State of California
Department of Water Resources
Sustainable Groundwater Management Program
Alternative Assessment Staff Report

Groundwater Basin Name: Coachella Valley – Mission Creek (Basin No. 7-021.02)
Submitting Agency: Coachella Valley Water District
Recommendation: Approve
Date Issued: July 17, 2019

Figure 1. Service Areas of the Local Agencies in the Mission Creek Subbasin (From Bridge Document Figure 2-2)

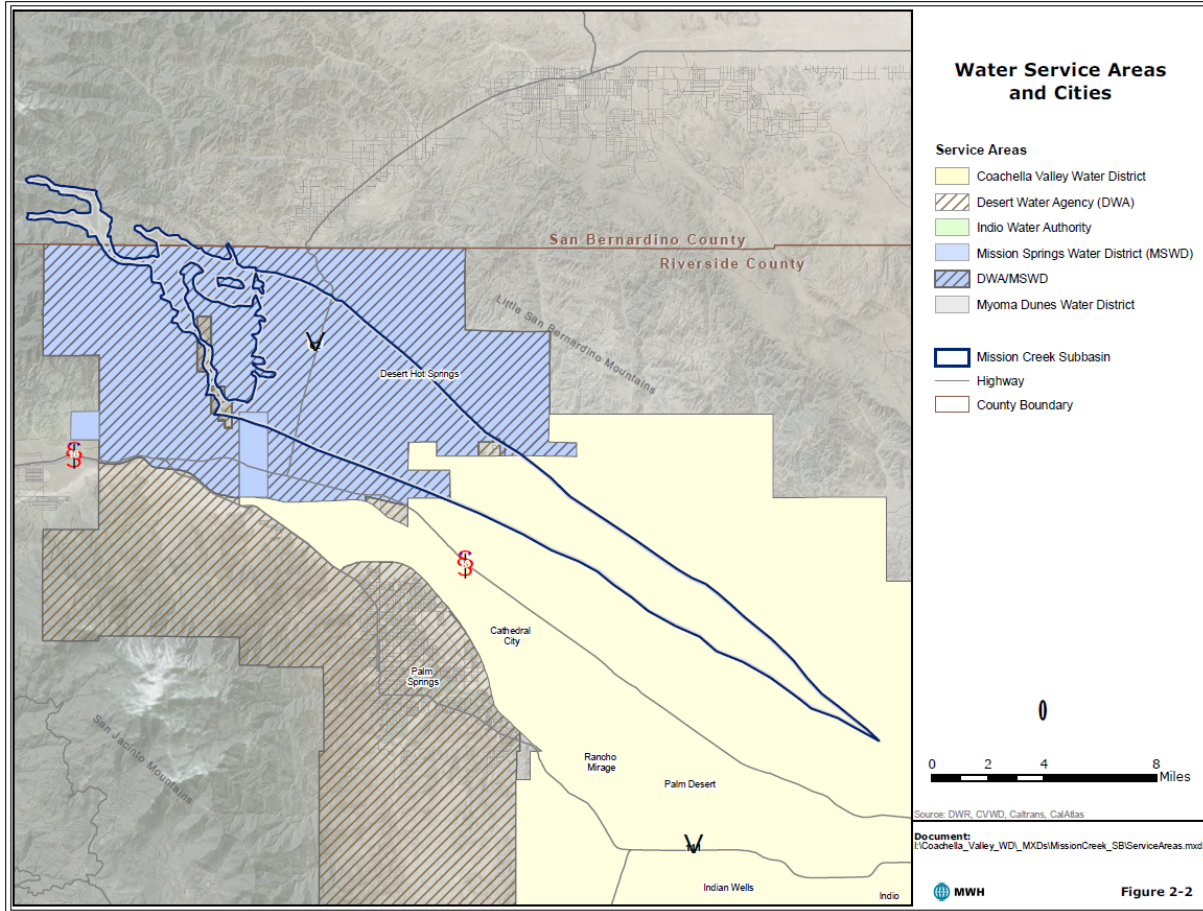
The Water Management Plan and Bridge Document include maps showing that nearly the entire Mission Creek Subbasin is within the jurisdictional areas of at least one of the Agencies (see Figure 1, below).³³ The Bridge Document indicates that the only portions of the Subbasin outside the jurisdictional area of the Agencies are small areas at the northwest portion of the Mission Creek Subbasin in San Bernardino County. The Bridge Document notes that all of those areas, except for less than one square mile, are federally-owned, and that the entirety of the non-jurisdictional area falls within the recently designated Sand to Snow National Monument, limiting future development in that area.³⁴

Based on the facts described and the verification of the approximate land use using aerial imagery, Department staff determined that the Water Management Plan effectively covers the entire basin from a jurisdictional standpoint. Considering the current extent of land use and the associated groundwater use in the areas outside of the Agencies’ jurisdictional boundaries, Department staff do not regard the exclusion of the northwestern portion of the Subbasin to pose a threat to successful implementation of the Water Management Plan and does not believe that implementation of the Plan is likely to adversely impact the ability of adjacent basins to achieve sustainability goals.

Figure 2. Map of the Mission Creek Subbasin and the Planning Area of the 2013 Water Management Plan (From Bridge Document Figure 2-6)

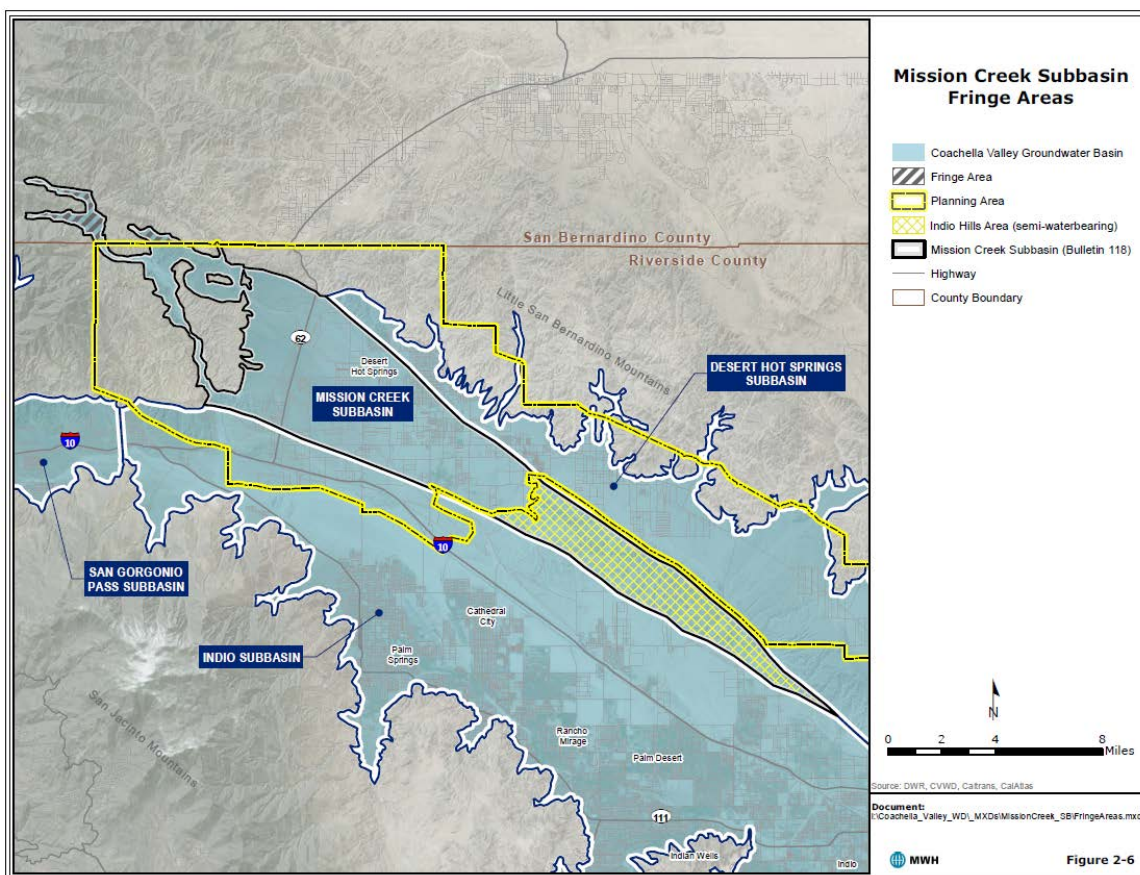
Department staff also considered whether the Water Management Plan intends to cover the entire basin from a management perspective. The southeastern portion of the Mission Creek Subbasin, as defined in the Department’s Bulletin 118, consists of the Indio Hills area (see Figure 2, below), which is within the jurisdiction of the Coachella Valley Water District but was not included in the planning area for the Water Management Plan (see

Figure 2, below).³⁵ Although the Indio Hills area accounts for a significant portion of the Mission Creek Subbasin area, the Agencies submitted evidence to show that the Indio Hills area does not need to be managed in order to sustainably manage the entire Subbasin. The Plan provides evidence that the Indio Hills area consists predominantly of low-permeability rocks units, and that the rocks with high aquifer-potential are structurally higher than the water levels in neighboring basins.³⁶ The Agencies' understanding of hydrologic conditions in the Mission Creek Subbasin is demonstrated in the Water Management Plan, Groundwater Flow Model, and the annual Engineer's Reports. The water inflows to and outflows from this area are included in the groundwater model³⁷ and discussed in more detail in the Water Budget section, below.

Based on the information provided by the Agencies and the verification of the approximate land use using aerial imagery, Department staff determined that exclusion of the Indio Hills area from the Water Management Plan's planning area is not likely to adversely impact the Agencies' ability to achieve sustainable groundwater management for the entire Mission Creek Subbasin.
